**LEVY NUCLEAR POWER PLANT, UNITS 1 AND 2
DOCKET NOS. 52-029 AND 52-030
SUPPLEMENT 3 TO RESPONSE TO REQUEST FOR ADDITIONAL INFORMATION
REGARDING THE ENVIRONMENTAL REVIEW**

NRC RAI #: 5.2.2-3

Discuss implementation of the DWRM2 TMR groundwater model. Discuss the predicted impacts of groundwater usage at LNP.

Progress Energy Florida Levy Nuclear Plant Units 1 and 2
SWFWMD DWRM2 TMR TMR Model Water Budget with LNP Withdrawing 1.58 mgd Attachment 5.2.2-3I Figure 8

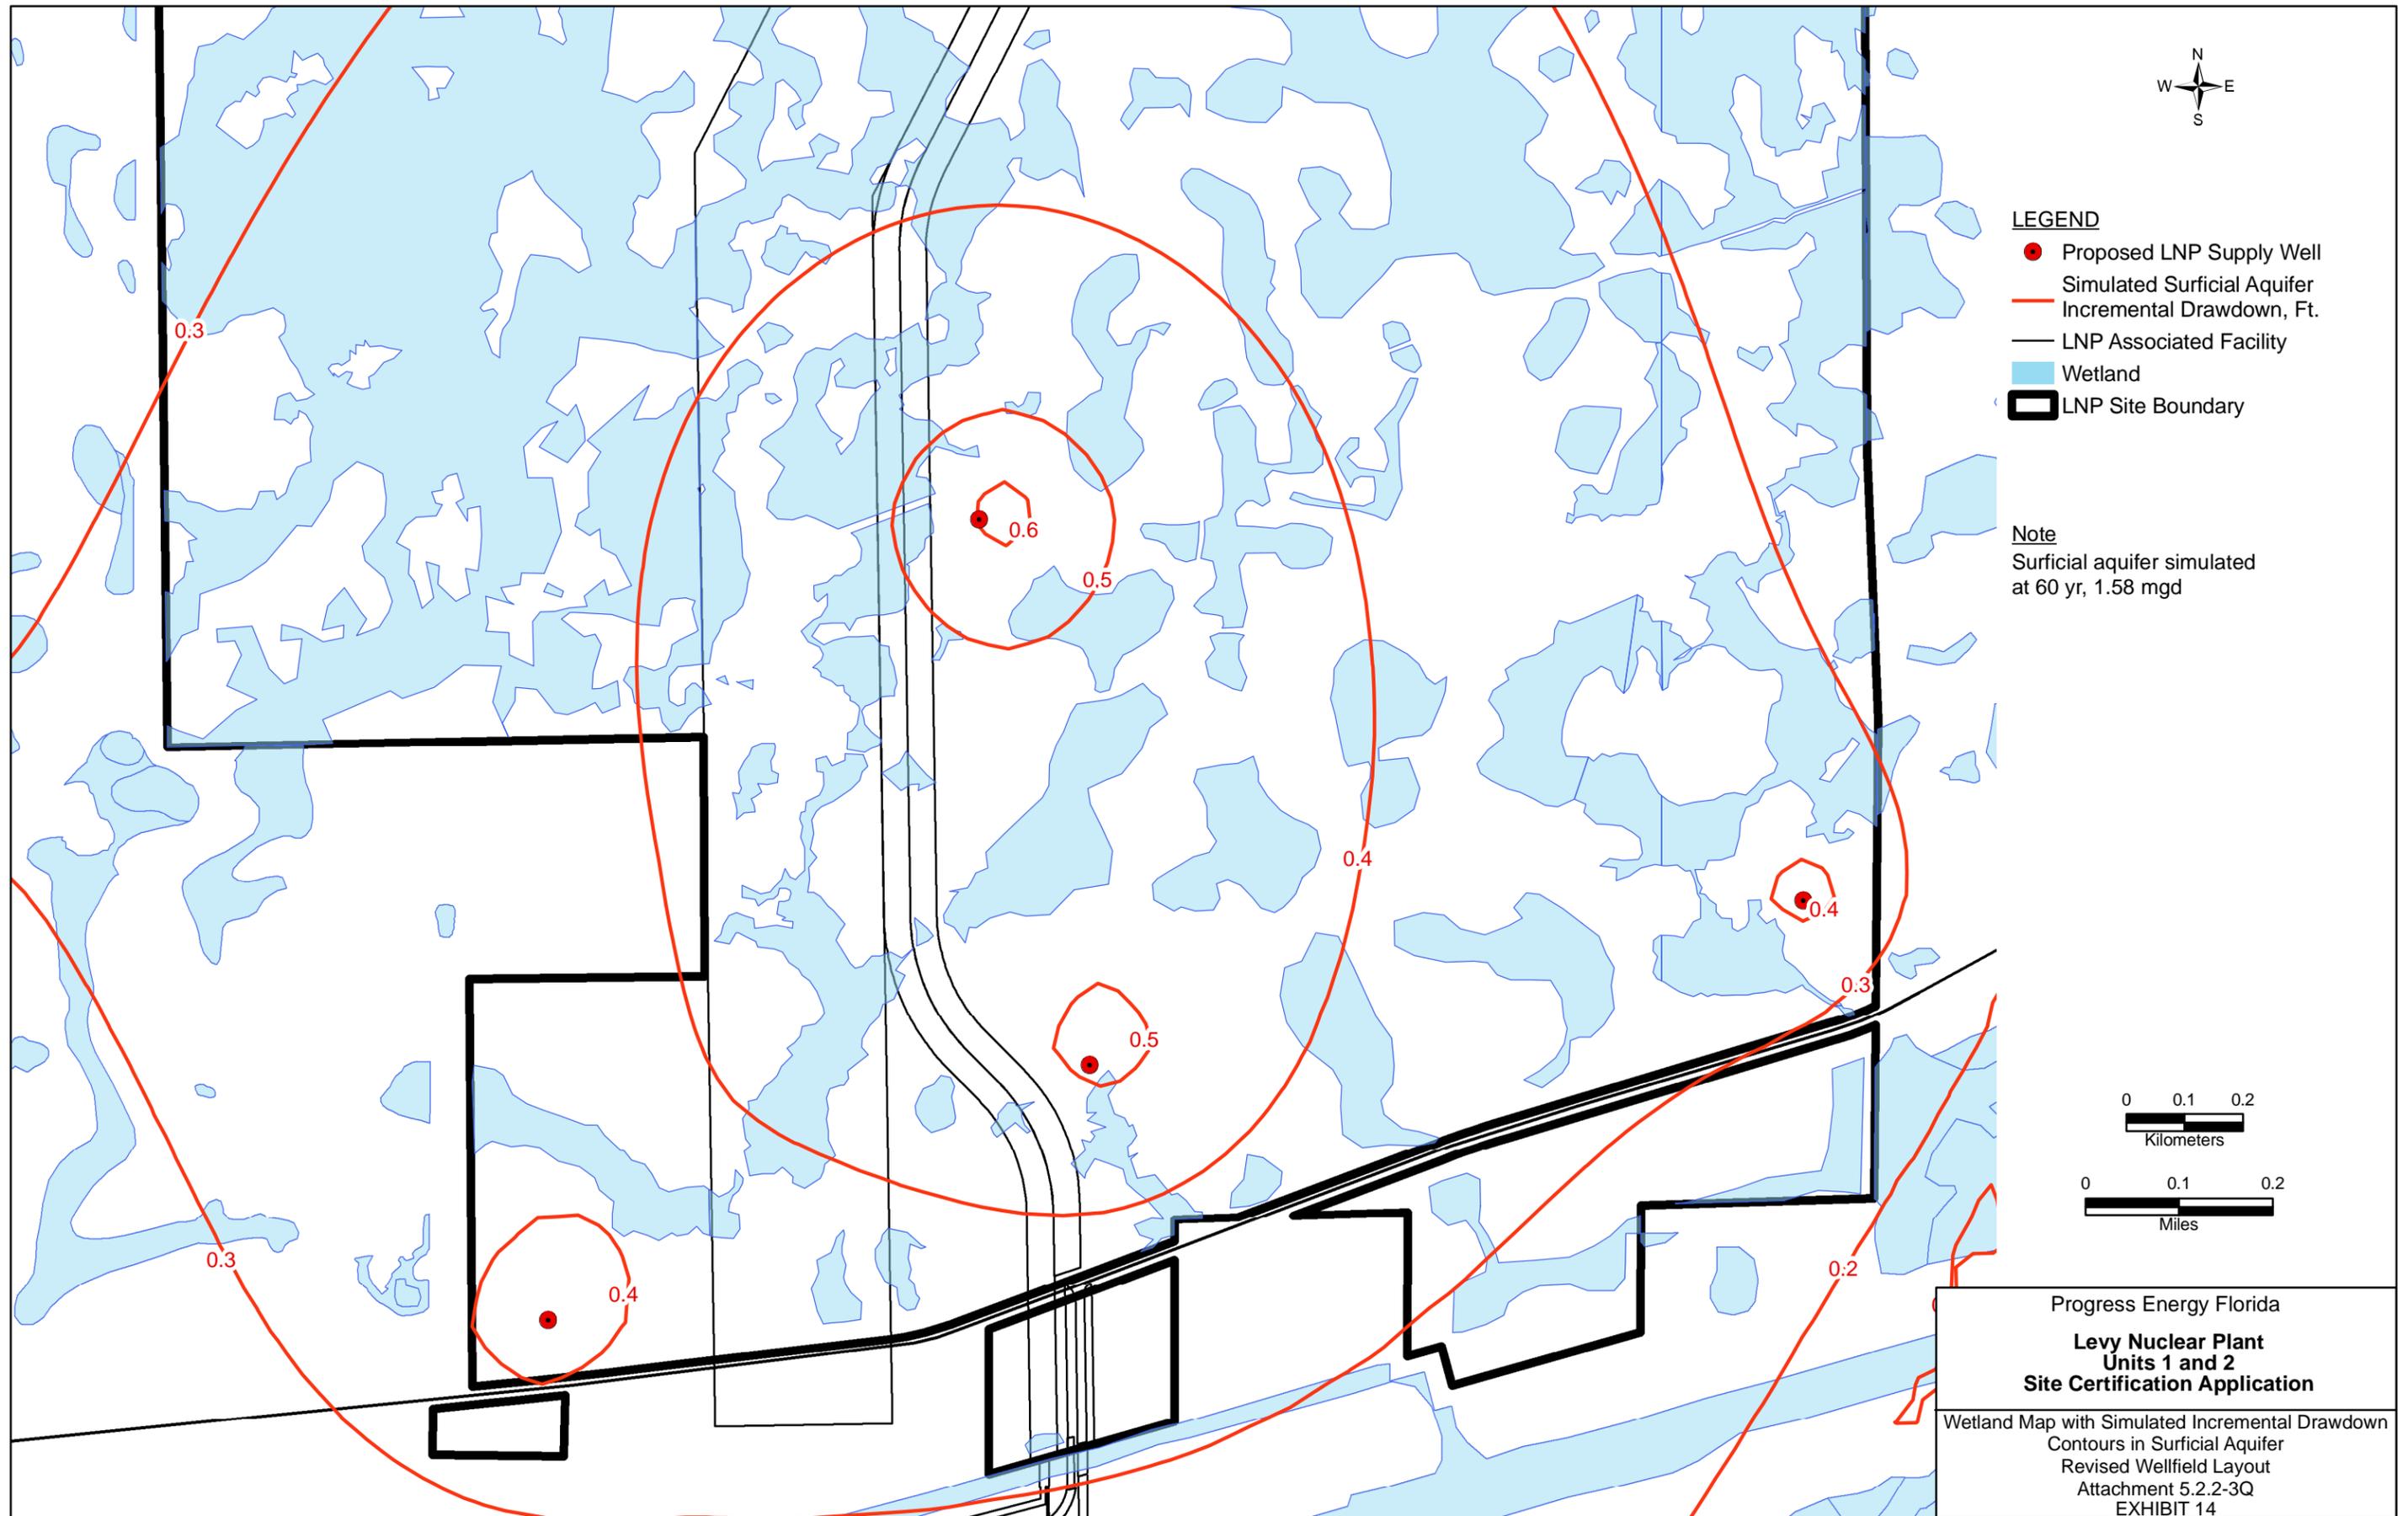
ER Section 5.2.2 stated that groundwater would be used for general plant operations. ER Section 5.2.1.4 stated that groundwater for operations would be obtained from on-site supply wells shown in ER Figure 4.2-1. During the site audit, the NRC staff became aware that the location of the supply wells had changed from those shown in ER Figure 4.2-1 and that PEF were using a groundwater model, DWRM2 TMR, to assess operational impacts of the groundwater withdrawal. Discuss implementation of the DWRM2 TMR groundwater model that is being used to assess impacts of LNP's groundwater withdrawals from the Floridan aquifer, including how surface recharge is implemented in the model and the impact associated with using projected future water use on a county-wide level (see ER Table 2.3-20) in the assessment. Discuss SWFWMD's process for managing groundwater resources.

Discuss the predicted impacts of LNP's groundwater usage on 1) the basin- or subbasin-scale water balance, 2) potentiometric heads within the aquifer, 3) wetlands, 4) discharge to springs and other surface water bodies, 5) other groundwater users, and 6) the potential for salt water intrusion.

As shown in Attachment 5.2.2-3I (Model Water Budget), the total inflow and outflow in the model is about 450 mgd. The model area covers only a small portion of the three-county area surrounding the property. Attachment 5.2.2-3I contains a summary of the TMR model Water Budget with LNP withdrawing 1.58 mgd. Each layer of the model is shown with the total flow into and out of the layer for the horizontal and vertical boundaries. Inflows are highlighted in blue; outflows are highlighted in yellow. Total inflows are about 450 mgd and total outflows are 450 mgd. The LNP withdrawal comprises only about 0.4 percent of the total flux through the model.

Regional water use was summarized in ER Subsection 2.3.2.4.1 for Levy County, Subsection 2.3.2.4.2 for Citrus County, and Subsection 2.3.2.4.3 for Marion County. The total groundwater use for the three counties was 59 mgd in 2005 and is projected to be about 80 mgd in 2025. As shown in Attachment 5.2.2-3I, the model groundwater budget, which includes only a small portion of the area of these three counties, is approximately 450 mgd. This is over 5.5 times the projected water use in these three counties. Therefore, the LNP withdrawal of 1.58 mgd is insignificant compared with the total model flux and the regional groundwater resources.
